RECEIPT DATE: 5/12/25 **ONSITE SEWAGE DISPOSAL SYSTEM** P 589089

PROPERTY ADDRESS: 15105 Devlin Drive

SUBDIVISION: Cattail Overlook LOT: 1 TAX ID: _____

SEPTIC SYSTEM INSTALLATION PLAN
CATTAIL OVERLOOK
LOT 1
15105 DEVLIN DRIVE, GLENELG, MD 21737
ZONED RC-DEO
TAX MAP No. 21 GRID No. 20 PARCEL No. 84
FOURTH ELECTION DISTRICT HOWARD COUNTY, MARYLAND
SCALE: AS SHOWN DATE: APRIL 21, 2025
SHEET 1 OF 1

PROFILE SEPTIC CL.
SCALE HORIZ. 1" = 40'
VERT. 1" = 4'

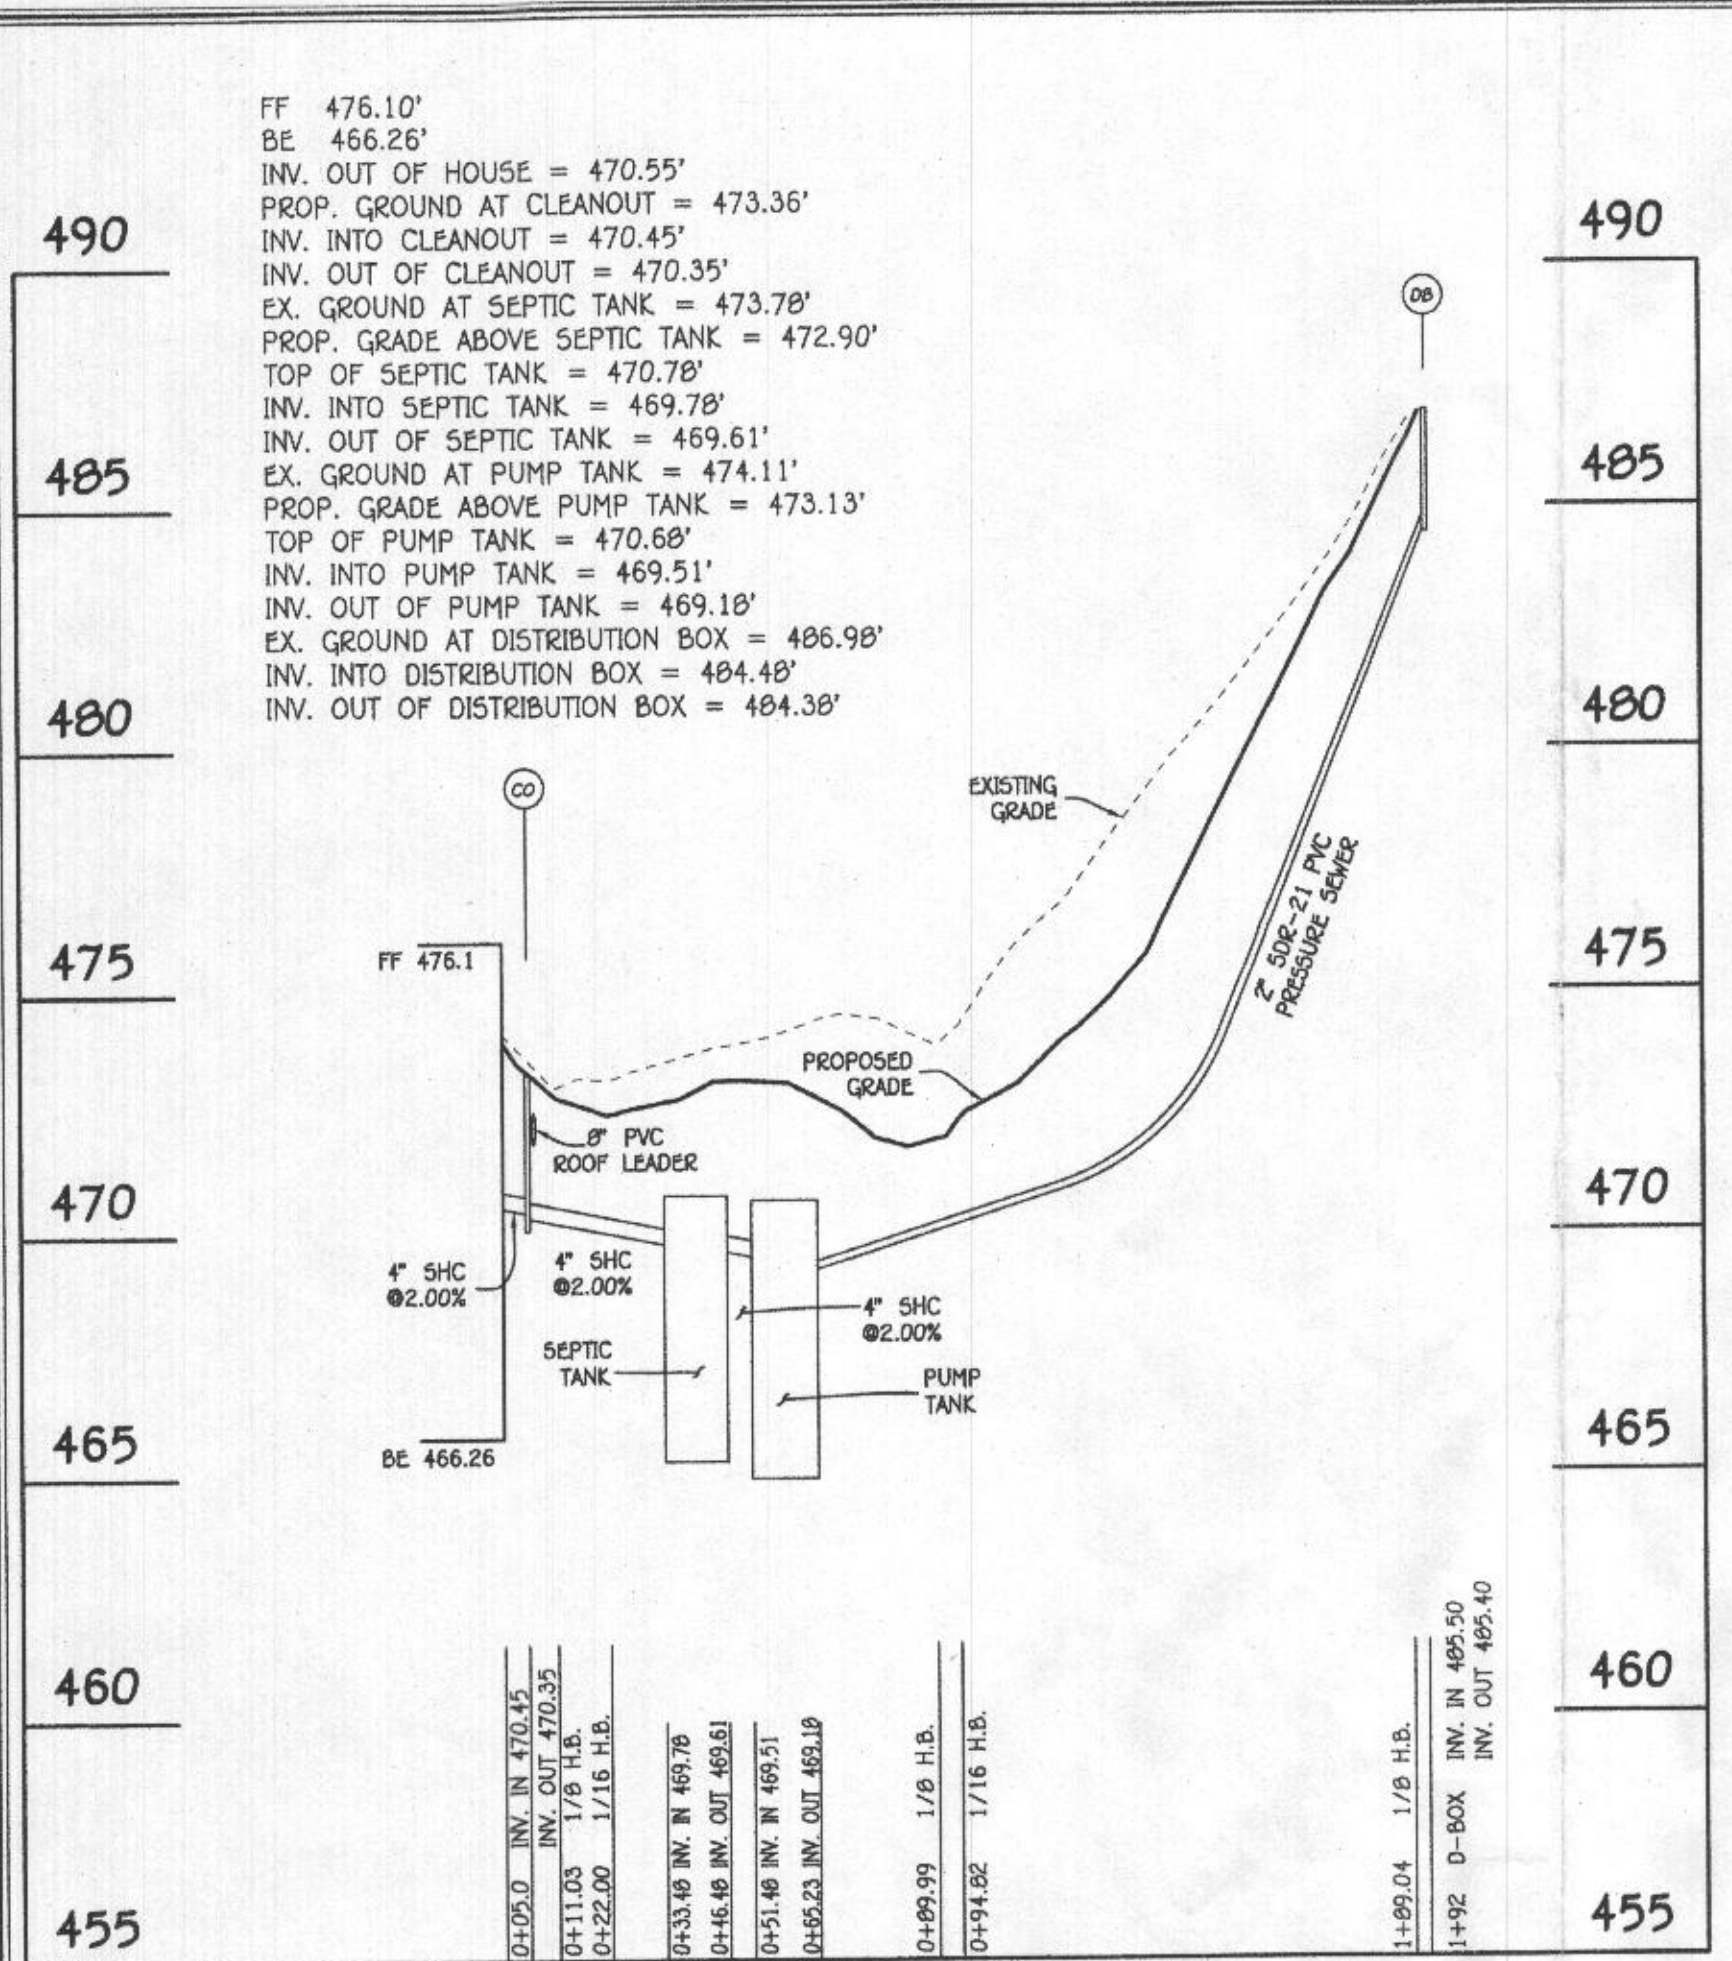
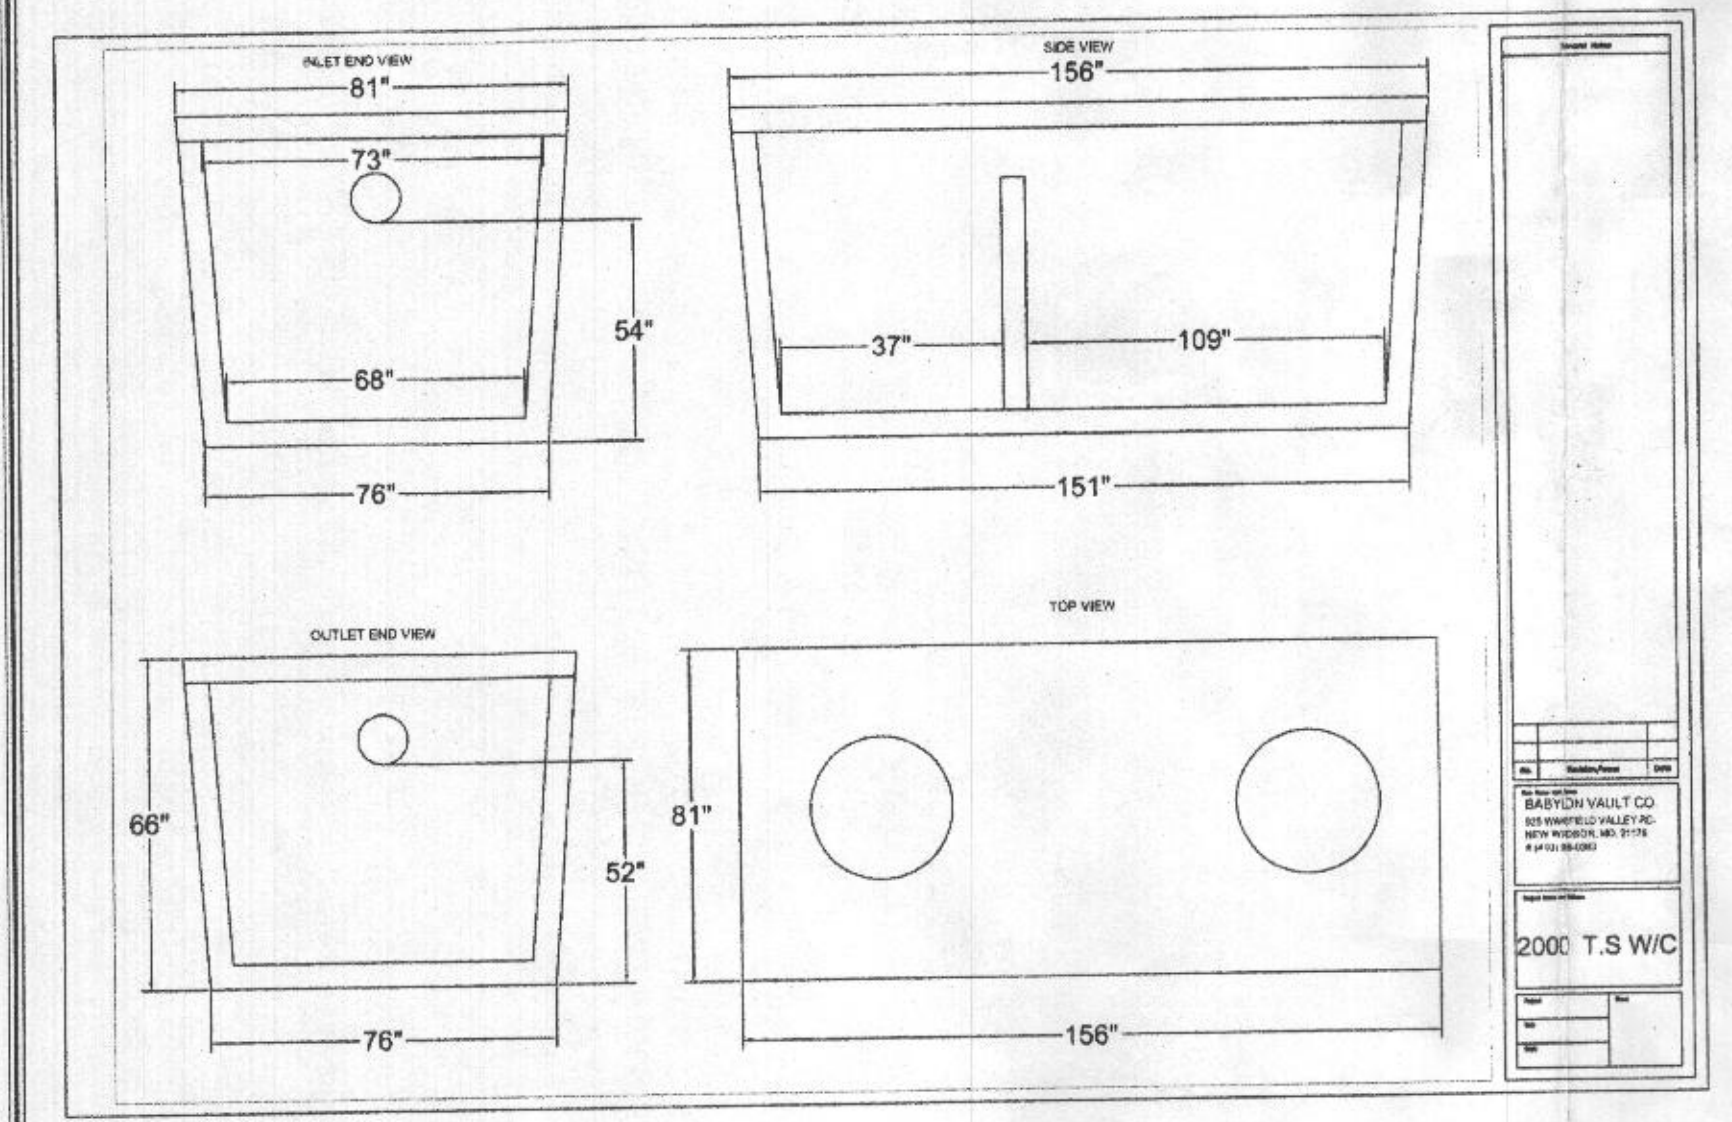
1. Show 8 in. roof leader in the septic profile.
2. Adjust inlet grate on future pool deck to be 25 feet from the septic tanks.
3. Initial trench detail - The effective depth should 2.5 feet (not 3.5 ft.).
